Maules Creek Mine PA10_0138 Submission on Modification 4 Sound Power Levels

1. Introduction

Whitehaven Coal has lodged an Environmental Assessment supporting its application to remove commitments to control the sound power levels ie noise emanated from the Maules Creek mine. It contains statements and omissions that call for clarification and correction, such as those statements pertaining to the compliance record of the mine and the noise impacts of noise in Maules Creek.

Figure 3.1 Red line is the disputed 35dB contour line, and the numbered dots correspond with properties mentioned in Table 3.1 above.

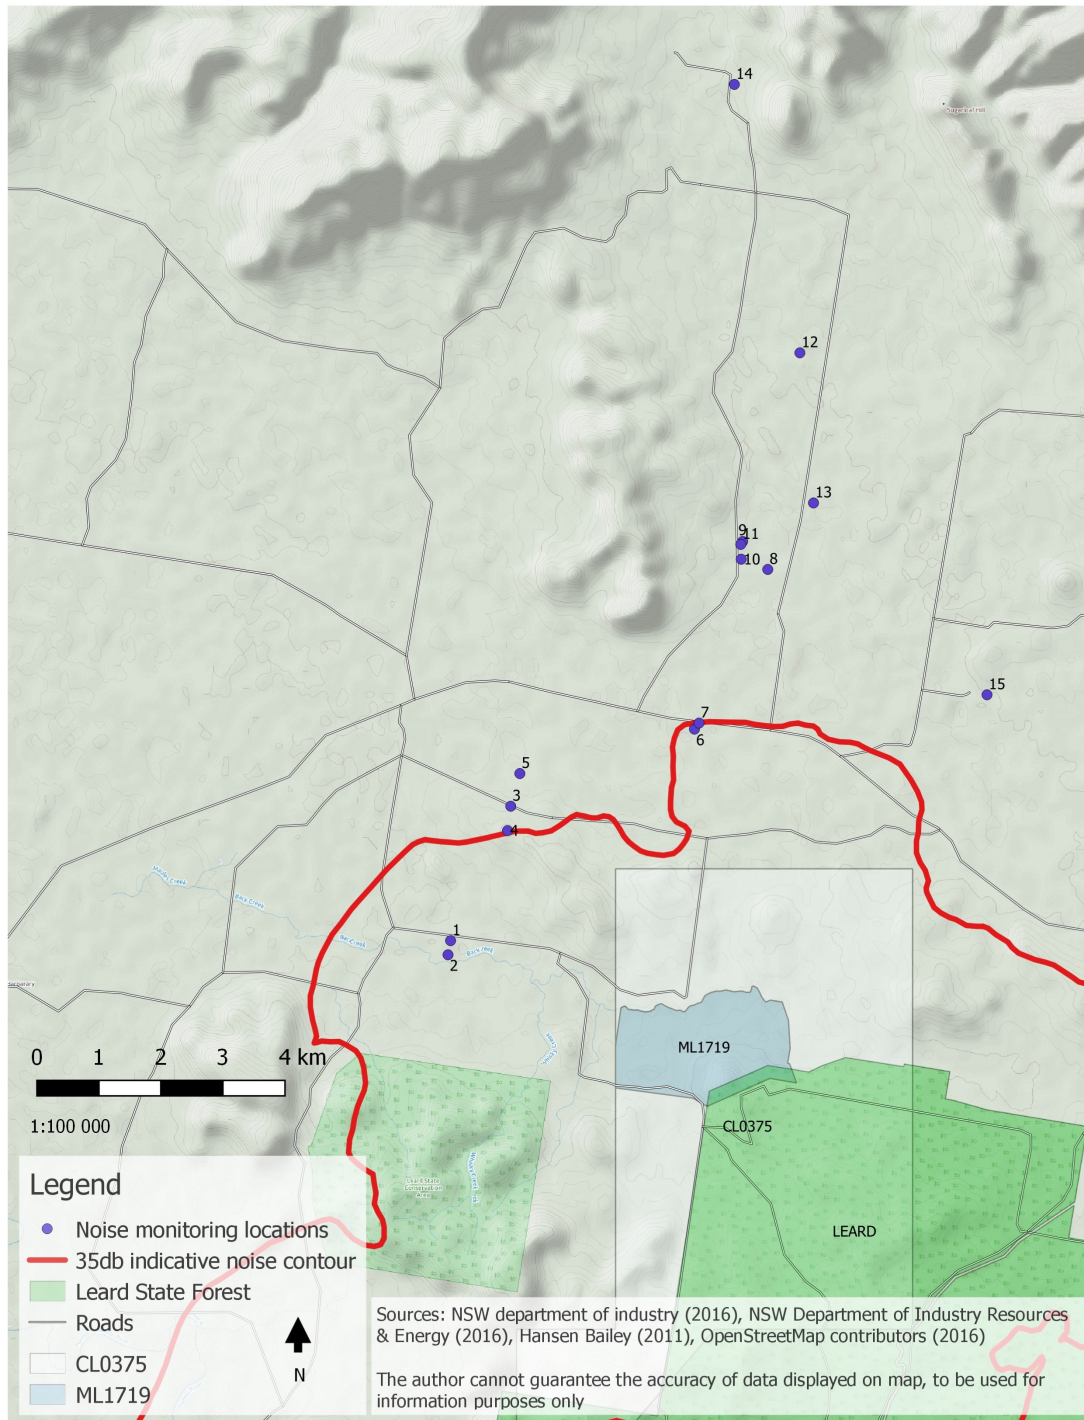
The affectation zone of the MCCM has been dramatically underestimated. The map shown below was prepared by the Leard Forest Research Node. The red line is where the 35

decibel line is – no one north of that line should have >35decibels 15 minute averaged at night, but community monitoring proved that many properties are affected by plus 35dBA averages.

Exactly due North of middle of mine area there is little topographical shielding. Properties in this northerly direction that are disturbed by the mine north of Harparary Rd and not included in their modelling.

Figure 5.2 Travelling Stock Route to be destroyed in red marks extent of mine expansion, coming February 2018

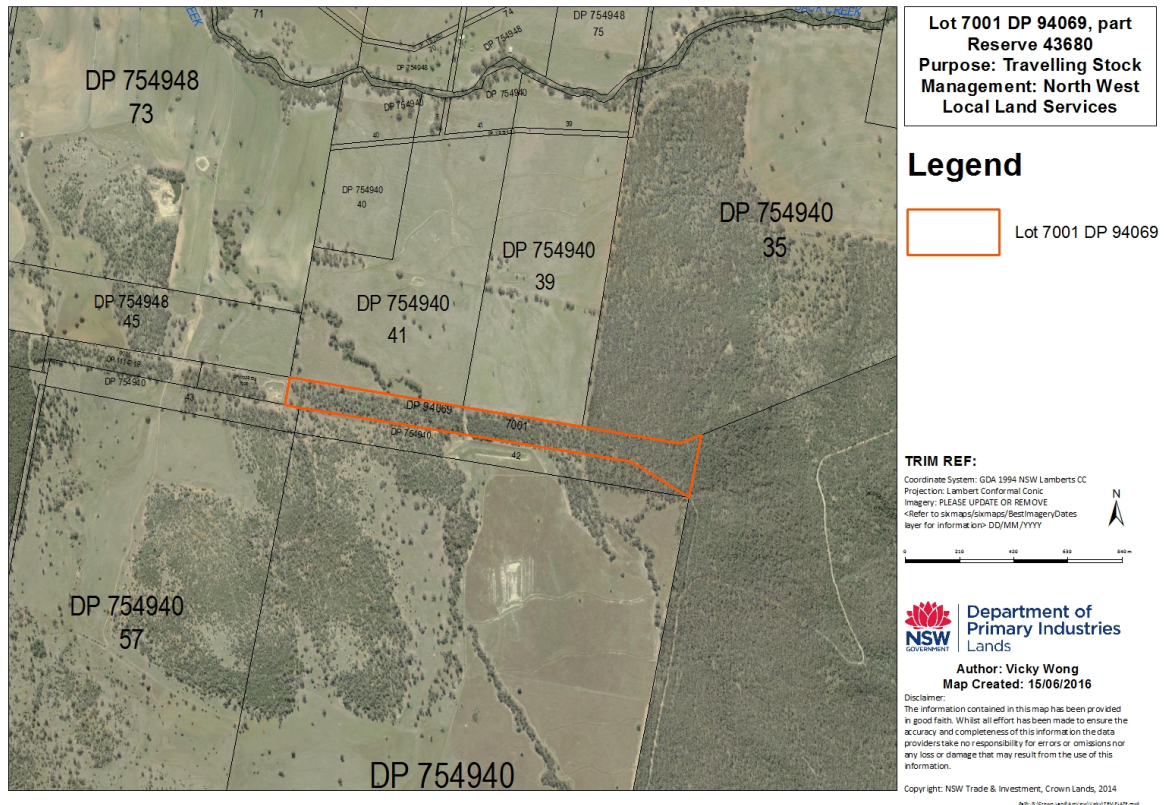
This coming February 2018, a major expansion of the mine to the west is planned. When Whitehaven bulldozes the East-West Travelling Stock Route, the North West boundary of mining operations will encroach around 1 km closer to residences that art to the north-west and the West.

To omit this critical piece of information is extremely deceptive, because obviously the proximity to affected community members is a key part of the equation.

The red marked area (below) represents the TSR to be bulldozed by Whitehaven Coal. This high Biodiversity value land will become working overburden area.

Figure 5.3 Shows the position of A346 which extends almost to the 35dB contour line to the North (see Figure 3.1)

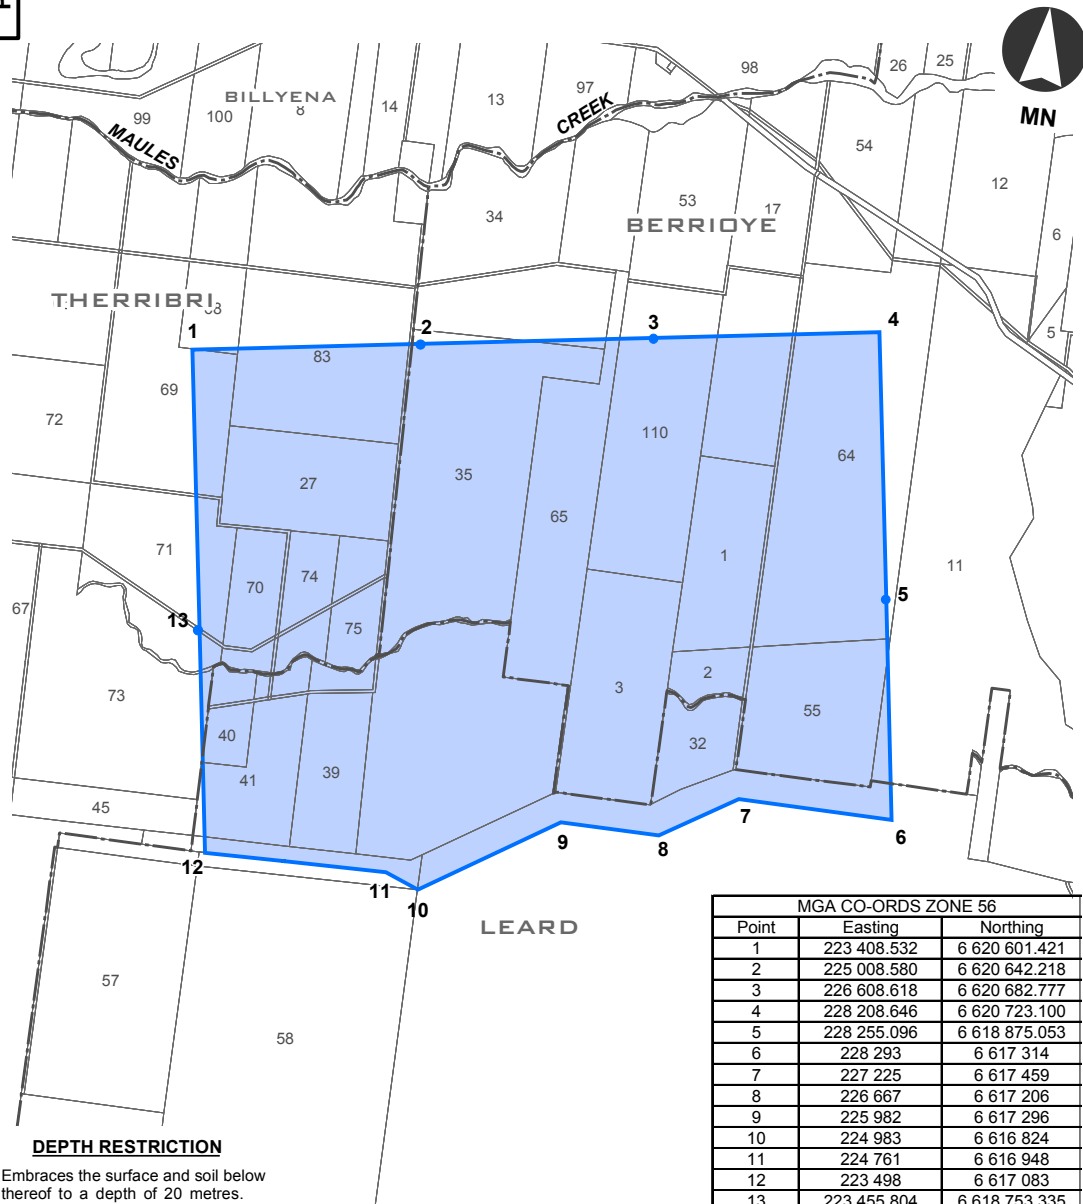
Whitehaven also has plans to extend the mine towards the north, under its active exploration licence A346 which it includes in its reserves as reported to the stock market. Weakening the noise controls under these circumstances will have grave consequences for community health and well-being.

Here is a diagram that shows A346, which will bring the mine much closer to the northern Maules Creek:
